# STATE OF ILLINOIS DEPARTMENT OF TRANSPORTATION

OVERHEAD SIGN STRUCTURES  
 HANDRAIL HINGE REPAIR DETAIL

PLAN  
DETAIL E HANDRAIL HINGE

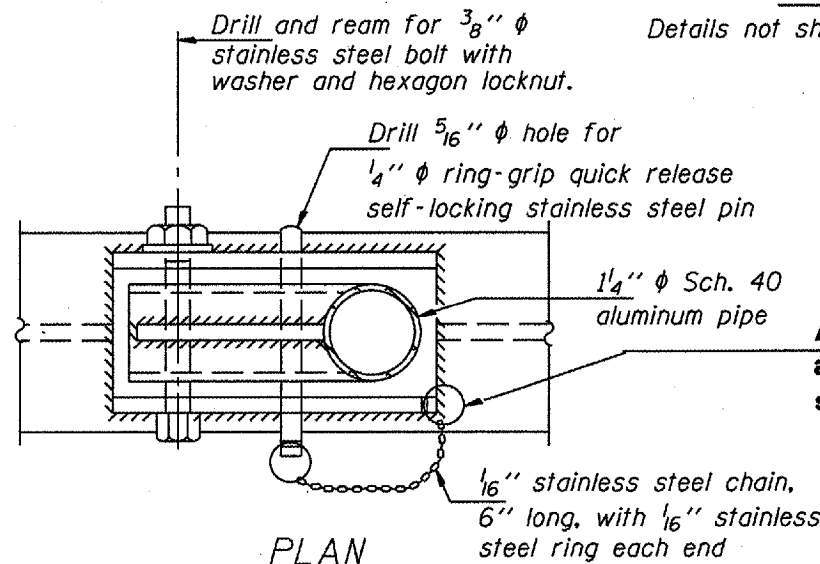
**The existing locking pin hole to be reamed for proper alignment and a new oversized stainless steel pin to be installed.**

**A new stainless steel chain shall be attached to the angle with a 1/16" stainless steel ring.**
